City Commission Staff Report

File No: 24-29

Application Name: 317 NE 168th Street

The item before the Planning & Zoning Board is a request for Site Plan Approval with variances for the construction of a 12-unit residential development on a corner vacant lot.

Proposed Site Plan:

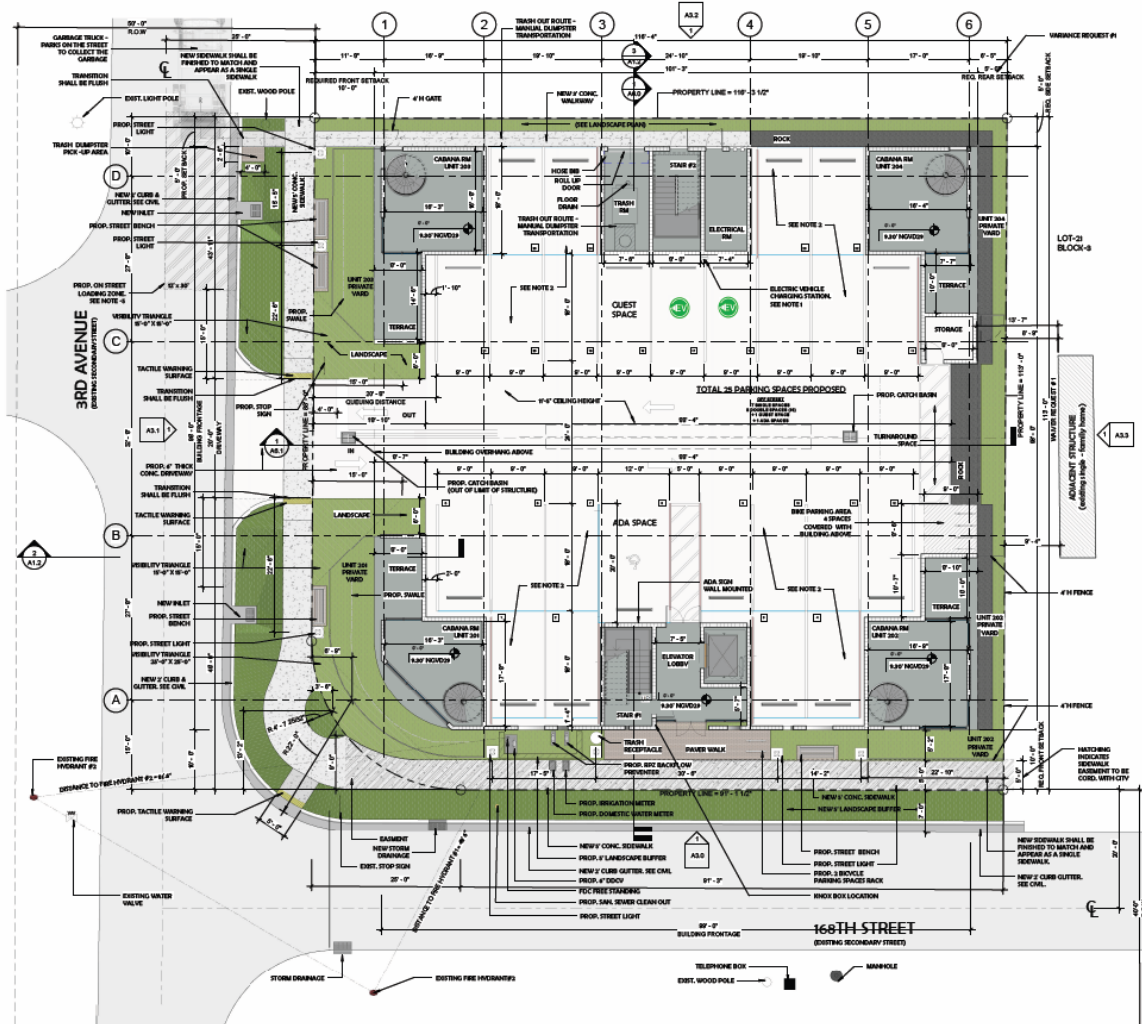
TOTALS	19 PARKING SPACES REQUIRED	25 PARKING SPACES PROPOSED
VARIANCE/WAIVER		
# 1. VARIANCE FOR REAR EAST SETBACK.	FOR THE FLEX BUILDING TYPOLOGY - 30 FT. INTERIOR SIDE AND REAR SETBACK REQUIREMENT WHEN ABUTTING AN EXISTING SINGLE - FAMILY HOME.	REQUESTED VARIANCE #1 NEW REAR EAST SETBACK = 5' - 0".

# 2. VARIANCE FOR SIDE NORTH SETBACK.	FOR THE FLEX BUILDING TYPOLOGY - 30 FT. INTERIOR SIDE AND REAR SETBACK REQUIREMENT WHEN ABUTTING AN EXISTING SINGLE - FAMILY HOME.	REQUESTED VARIANCE #2 NEW SIDE NORTH SETBACK = 5' - 0".

# 1 WAIVER FOR NEW LOT DEPTH	FOR THE FLEX BUILDING TYPOLOGY - LOT DOES NOT MEET THE MINIMUM LOT DEPTH OF 130 FT.	REQUESTED WAIVER #1 NEW LOT DEPTH = 113' - 0"

The Applicant is seeking a non-use variance to permit the allowance of a rear setback of 5 feet in lieu of the required 30 feet.

The Applicant is seeking a non-use variance to permit the allowance of a side setback of 5 feet in lieu of the required 30 feet.

The Applicant is seeking a non-use variance to permit the allowance of a 1,113 square foot open space in lieu of the 4,052 square feet required.

- **Staff Recommendation:** Staff finds no objections to the rear setback variance. If granted, the proposed non-use variance does not appear to affect the stability and appearance of the community or create any incompatibility with the surrounding land uses.

- **Staff Recommendation:** Staff finds no objections to the side setback variance. Granting the variance will allow for the applicant to use the property as it has been platted. If granted, the proposed non-use variance does not appear to affect the stability and appearance of the community or create any incompatibility with the surrounding land uses.

- **Staff Recommendation:** Staff finds no objections to the public open space variance. Granting the variance will allow for the applicant to use the property as it has been platted. If granted, the proposed non-use variance does not appear to affect the stability and appearance of the community or create any incompatibility with the surrounding land uses.
